**REZONING, PUD, SUBDIVISION &  
SIDEWALK WAIVER STAFF REPORT****Date: November 18, 2010****APPLICANT NAME**

High Gear Land Development, LLC

**DEVELOPMENT NAME**Pinehurst, Delaney's Addition to Spring Hill, Block 21,  
Resubdivision of and Addition to Lot 18**SUBDIVISION NAME**Pinehurst, Delaney's Addition to Spring Hill, Block 21,  
Resubdivision of and Addition to Lot 18**LOCATION**East side of Wesley Avenue, 600'± South of Airport  
Boulevard.**CITY COUNCIL  
DISTRICT**

# DETAIL SITE PLAN

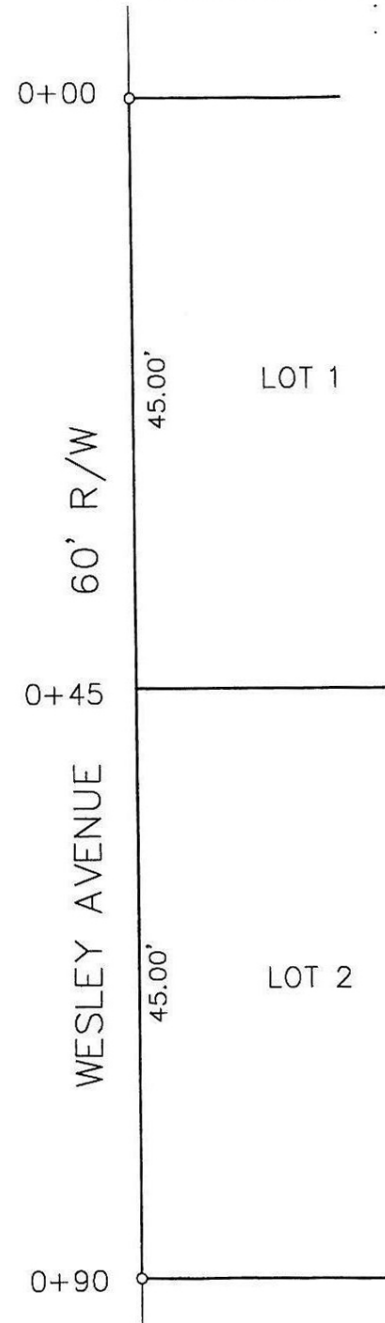
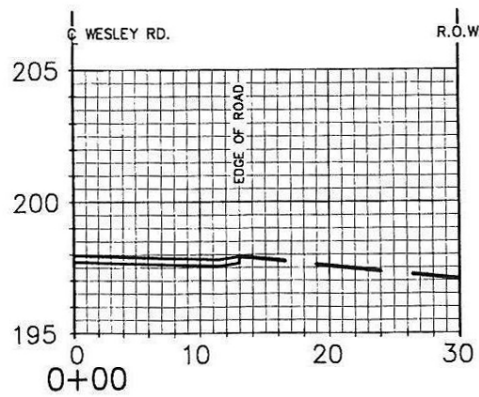
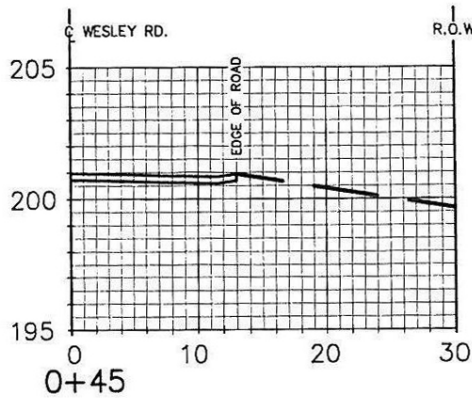
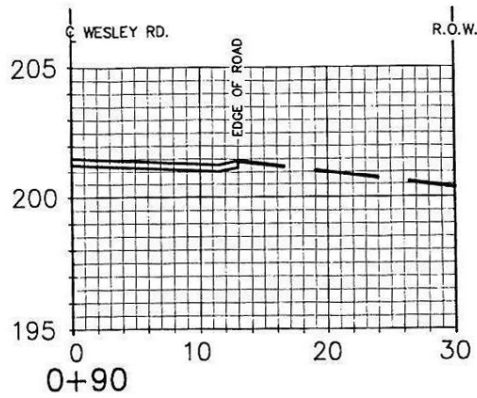
Regarding the sidewalk waiver request, it is recommend for approval due to slope.

The applicant states that the sidewalks requirements should be waived due to the site being located within an old established neighborhood with no sidewalks along any streets in the Pinehurst area.

A sidewalk waiver application for the development adjacent to the site was approved in 2009, thus it would seem that a waiver for this site would be a consistent policy decision for this street. However, this site is adjacent to traffic calming devices, which indicate that traffic problems have been determined to exist on the street, thus the provision of a sidewalk may be justified. Without a sidewalk, any person walking through the neighborhood is left with a choice of walking in the street, or walking in the adjacent landscape area. Engineering, however, states that the waiver request should be approved due to the

**Sidewalk Waiver:** Based on the preceding, the sidewalk waiver along Wesley Avenue is recommended for Approval.
